## SERVICE BULLETIN Amateur Radio Division

SUBJECT TS-940S MRF-485 Driver Transistor Notes

DATE January 16, 1992

Size Document Number SB-986  
A  
REV

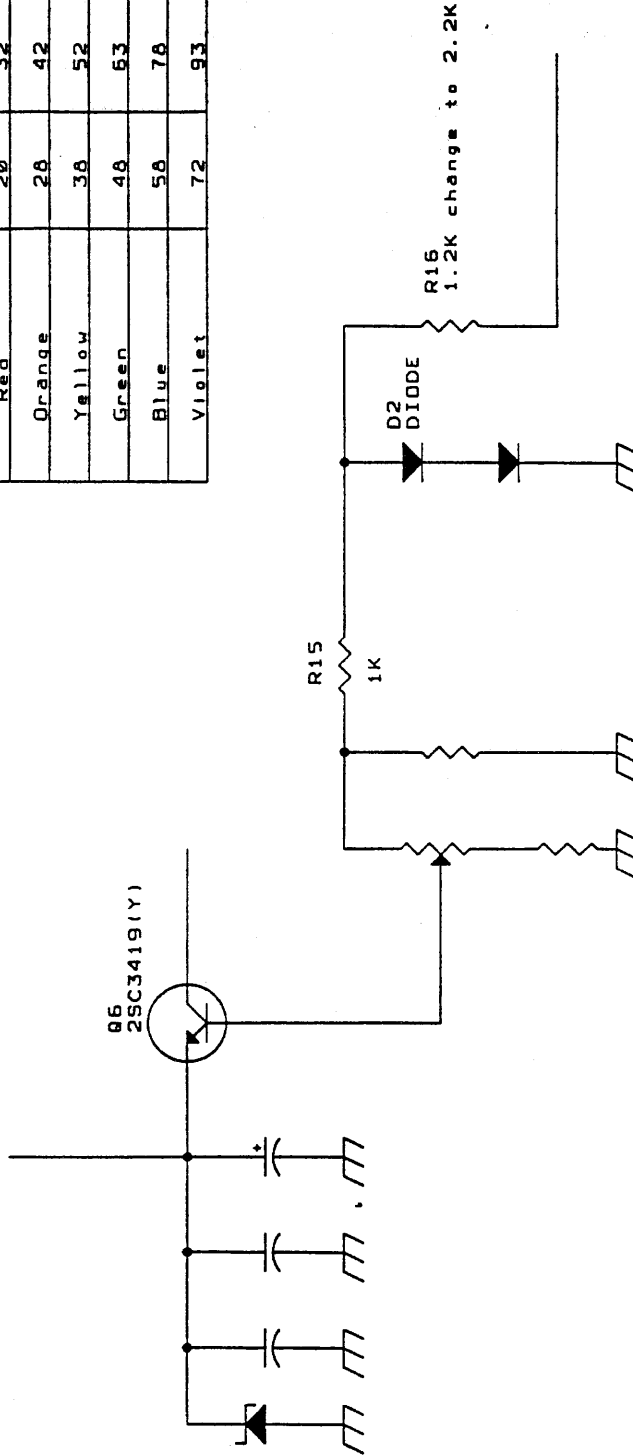
Some MRF-485 transistors are being supplied by Motorola with a Green or Blue color ranking. If these transistors are installed without modifying the driver bias circuit there is a very strong possibility that they will fail within a very short time frame.

These high gain transistors cause the circuit to become unstable which can cause the circuit to break into self oscillation, and therefore self-destruct.

During its production the TS-940S used two different varistor values. The original part was an STV3H (O). It was changed in mid-production to an SV-03YS. R15 was changed from an 820 ohm resistor to a 1K ohm resistor at the same time. Therefore the countermeasure differs depending upon the serial number of the radio.

**Caution:** If using a Green or higher hfe rank one of the above countermeasures must be taken depending upon the serial number of the set. After replacing the drivers check the bias current. We recommend transmitting for 1 hour in the SSB mode with no modulation into a dummy load. After this time frame check the bias current. It must not exceed 300 mA on the original radio. If the current changes you must change R16 from 1.2K to 2.2K.

Use of Red, Orange, or Yellow hfe color rankings is recommend. These lower gain transistors work just fine and do not suffer from the circuit instability problem. If you are only able to obtain the higher gain transistors you will need to modify the varistor/temperature compensation circuit on the final unit (X45-1400-00) by changing R16 from 1.2K to 2.2K ohms.
